TAC 56133

TECHNICAL EVALUATION OF THE
DETAILED CONTROL ROOM DESIGN REVIEW
FOR
WISCONSIN PUBLIC SERVICE CORPORATION'S
KEWAUNEE NUCLEAR POWER PLANT

March 14, 1986

Figure 1- Design Modification Process

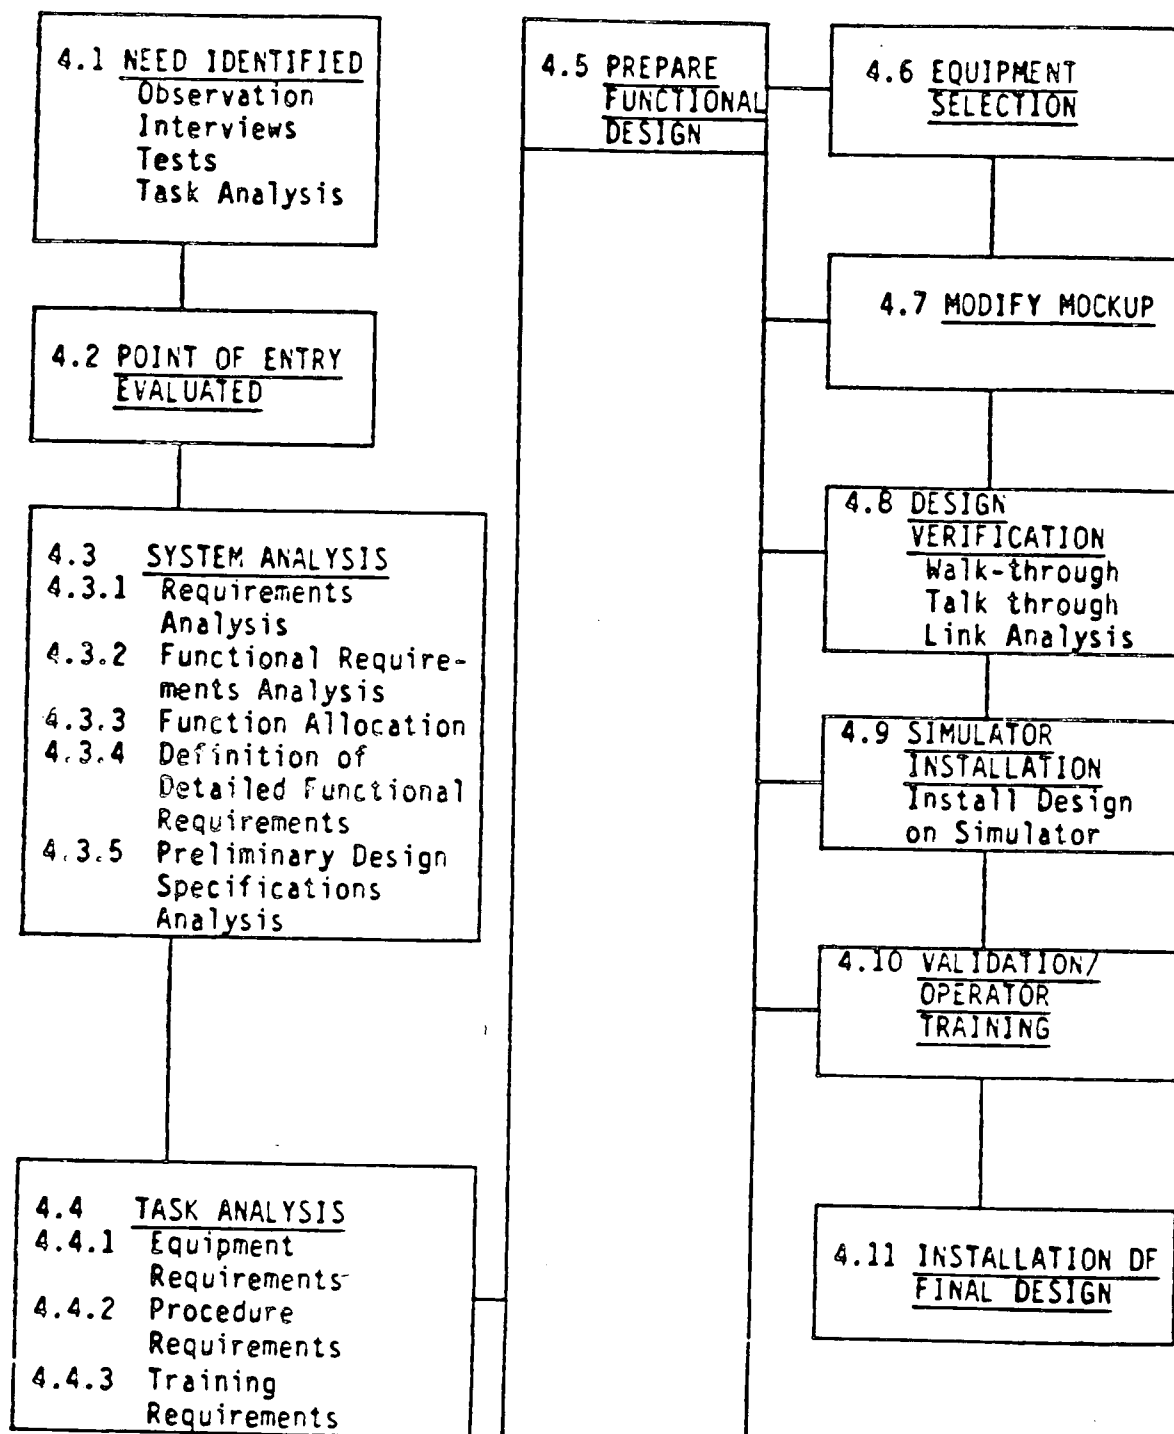
In order to address the NRC/SAIC concerns regarding the selection of design improvements, the licensee prepared a Human Engineering Review Process for Control Room Modifications flow chart (See Figure I). This flow chart was presented by the DCRDR team to the NRC at the February 12, 1986, meeting (Reference 2). The steps in the design modification process are as follows:

Based on the licensee's description of the design improvement process, it is the reviewers' evaluation that the process and results should satisfy the requirements of Supplement 1 to NUREG-0737. However, two important pieces of documentation will be needed to fully satisfy the Supplement 1 to NUREG-0737 requirement. The supplement to the Summary Report should document the selection of the design improvement process described in the February 12, 1986, meeting. Second, the supplement to the Summary Report should outline the proposed control room changes, including their schedules for implementation. This second item is essential to satisfying the documentation requirements of Supplement 1 to NUREG-0737.

In an effort to resolve this concern, the licensee presented a "draft" flow chart and description of the verification process at the February 12, 1986, meeting (Reference 2). The Design Modification Process flow chart (see Figure 1) illustrates the process that will be followed to verify that the modification corrects the HED and does not introduce new HEDs. This flow chart will be part of Engineering Control Procedure No. 4.2, "Human Engineering Review Process for Control Room Modifications." The verification process, as described by the licensee and illustrated in the flow chart, should satisfy the requirements of Supplement 1 to NUREG-0737.

In summary, the verification processes outlined in draft form, should satisfy this Supplement 1 to NUREG-0737 requirement. However, the licensee should provide a description of the final Engineering Control Procedure 4.2 in the Supplement to the Summary Report.

The coordination of the DCRDR with training is illustrated in the Engineering Control Procedure for Human Engineering Review Process for Control Room Modifications (Reference 2), see Figure 1 in this report. As part of the licensee's design modification process, the training requirements for modifications are defined along with equipment requirements and procedure requirements. The actual operator training on the modifications is implemented during the Validation/Operator Training step in the design modification process. Based on this information, it is the reviewers' evaluation that operator training is appropriately integrated into the DCRDR.
